# Techstream Cannot Command Self-EVAP Test

YEAR(S)	MODEL(S)	ADDITIONAL INFORMATION
2016 - 2018	LX570

Some 2016 – 2018 model year LX570 vehicles may exhibit a condition where the Techstream EVAP System Check Utility will not run as shown. The Transmission Control Module (TCM) logic has been modified to address this condition. Follow the Repair Procedure in this bulletin to address this condition.

**Figure 2. Location of Authorized Modifications Label for 2016 – 2018 LX570**

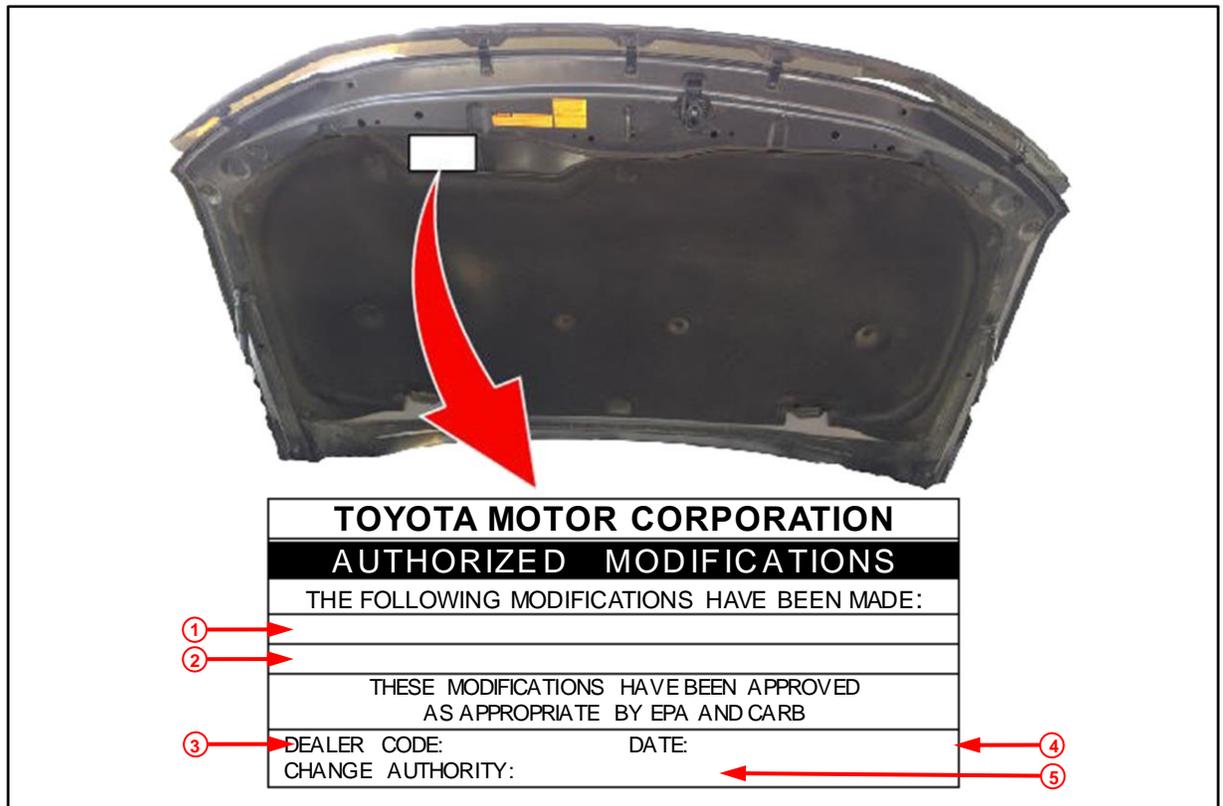
4. Prepare and install the Authorized Modifications Label.
  - A. Using a permanent marker, enter the following information on the label:
    - TCM part number [*Refer to the **Parts Information** section for the **NEW PART NUMBER***]
    - Calibration ID(s) [*Refer to the **Calibration Information** section for the **NEW CALIBRATION ID***]
    - Dealer Code
    - Repair Date
    - Change Authority [***This bulletin number***]
  - B. Install the Authorized Modifications Label to the vehicle at the location shown in Figure 2. The Authorized Modifications Label is available through the MDC, P/N 00451-00001-LBL.

**Figure 3.**

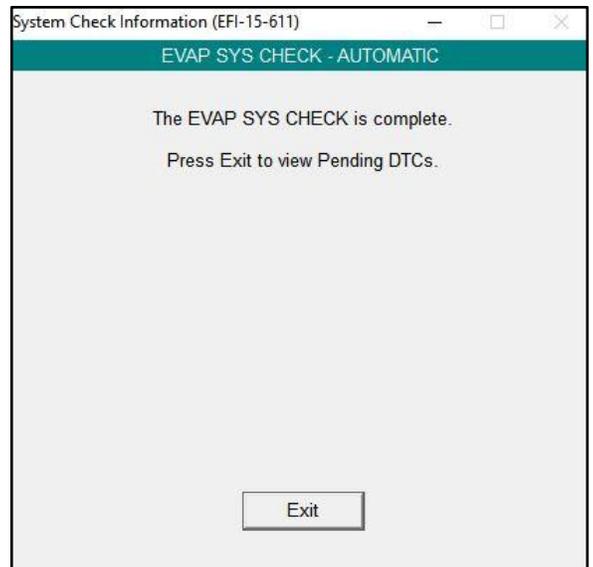
5. Connect Techstream to the vehicle and run the EVAP System Check Utility (*Engine and ECT – Utility – Evaporative System Check*).  
Confirm proper operation as shown.
